## 2 Johnston St Subdivision

Response to NPDC Request for Additional Information  
7905565 (PPC18/00049)  
19 December 2018

for Hareb Investments Limited

Rev B - 05-03-2019

Figure 1 : Receiving Sewer Reticulation

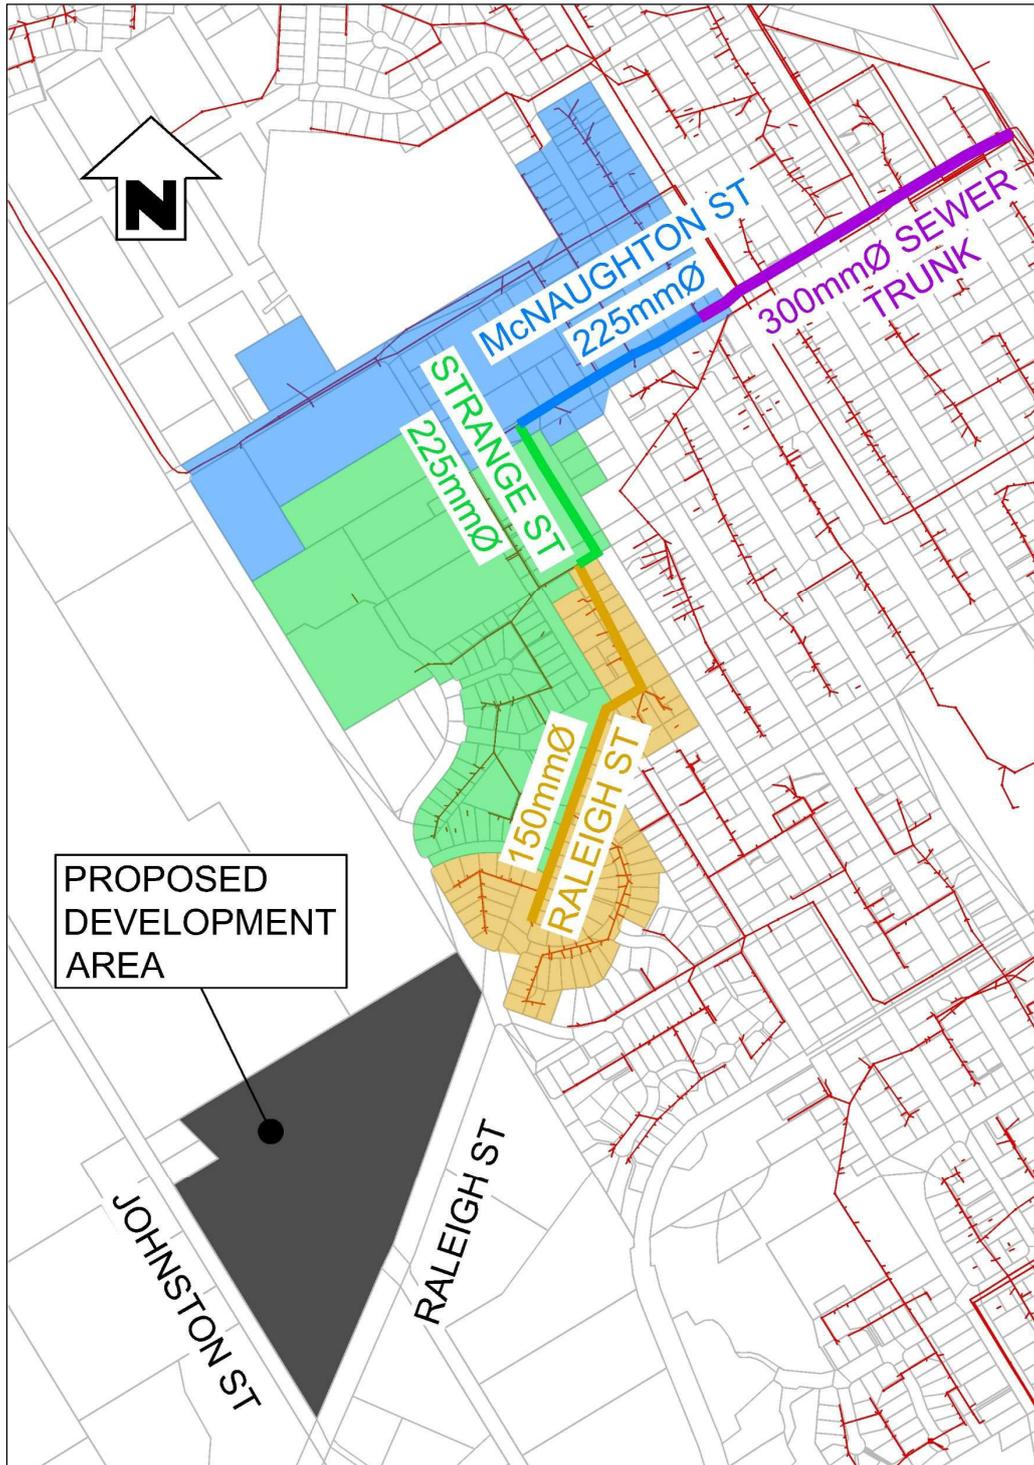
*“The plan change request provides high level calculations regarding sewer and water capacity. New Plymouth District Council has acknowledged that it does not have the resources to do this modelling. Can you provide a more detailed assessment to support this assumption? Water needs to be assessed at 60% Peak Daily Flow plus fire demand.”*

The sewer capacity analysis is based on skeletonising the existing sewer pipes into three lengths as illustrated in Figure 1 below, namely:

1. Raleigh Street, 150mm diameter sewer pipe – From manhole WA-RALEI0029SH (pipe invert level 28.32) to manhole WA-MOUL0085SH (pipe invert level 7.78m).
2. Strange Street, 225mm diameter sewer pipe – From manhole WA-MOUL0085SH (pipe invert level 7.78m) to manhole WA-STRAN0092SH (pipe invert level 6.80m).
3. McNaughton Street, 225mm diameter sewer pipe – From manhole WA-STRAN0092SH (pipe invert level 6.80m) to manhole WA-BROAD0098SH (pipe invert level 3.91m)

As can be seen from Table 1 above, each of the sewer mains has additional capacity for 4.1 L/s of sewage from the proposed development area.

Figure 4: Detention Pond Outlet Pipe size – EXAMPLE ONLY

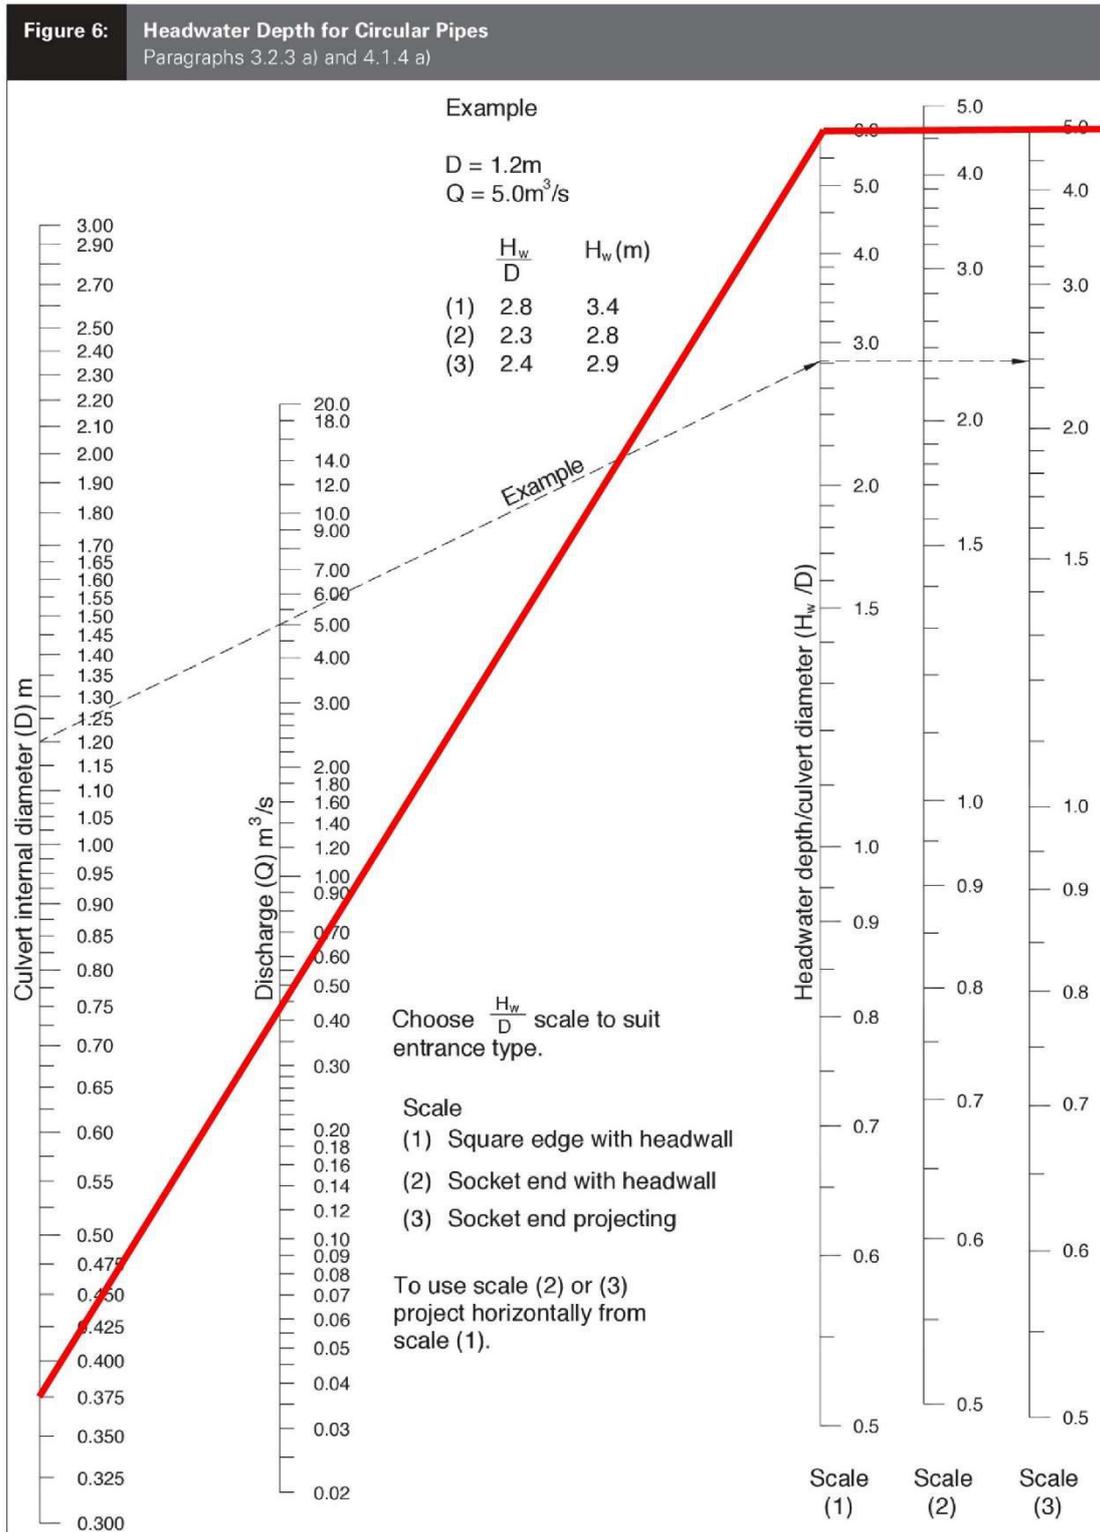
*“As the reserve will be vegetated the probability of vegetation debris will be high. Outline what size pipe would discharge from the detention bund to achieve the throttling of flow. Additionally, comment on how the risk of pipe blockage would be mitigated.”*

- Peak pre-development stormwater flow for 10% AEP storm event = 448 L/s
- A stormwater bund RL of 28.25m (which would provide a detention volume of 1,416m<sup>3</sup>) provides a headwater level of 2.25m (RL of stream invert = 26.0m)
- A stormwater outlet pipe with an internal diameter of 375mm
- $HW / D = 6.0$

As can be seen from Figure 4 above, a bund constructed with a top RL of 28.25m (which provides a total of 1,416m<sup>3</sup>), and a 375mm diameter outlet pipe will result in a maximum of 448 L/s outlet flow.

Figure 2 Impact of development on peak day pressures in the 150mm pipe along Raleigh Street

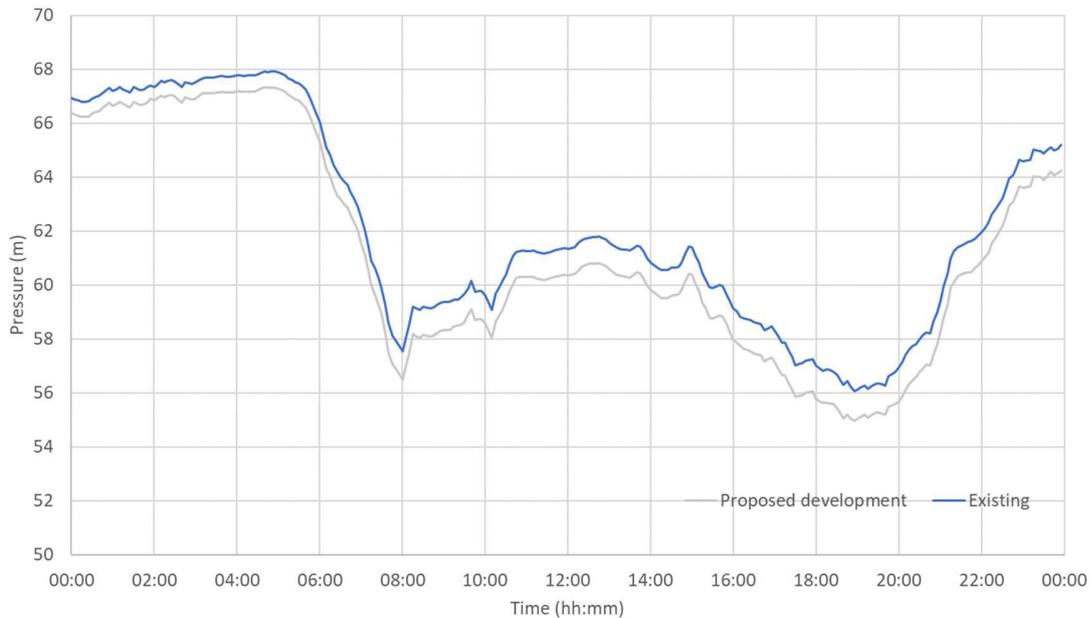
*“The plan change request provides high level calculations regarding sewer and water capacity. New Plymouth District Council has acknowledged that it does not have the resources to do this modelling. Can you provide a more detailed assessment to support this assumption? Water needs to be assessed at 60% Peak Daily Flow plus fire demand.”*

The peak day model has been run with and without the proposed development consumption. As shown in Figure 2 the proposed development results in a localized pressure reduction of approximately one meter during peak demand. It is noted that this assessment assumes a constant flow; if a residential consumption profile is applied to the development, then this would result in a larger impact on minimum pressures.

In general, the greatest effect of the development occurs in the localised area, resulting from headloss along the 150mm pipe. Current model-predicted head loss along this AC main is 2.2 m/km during peak demand, with an increase to 2.5 m/km as a result of the increased demand.
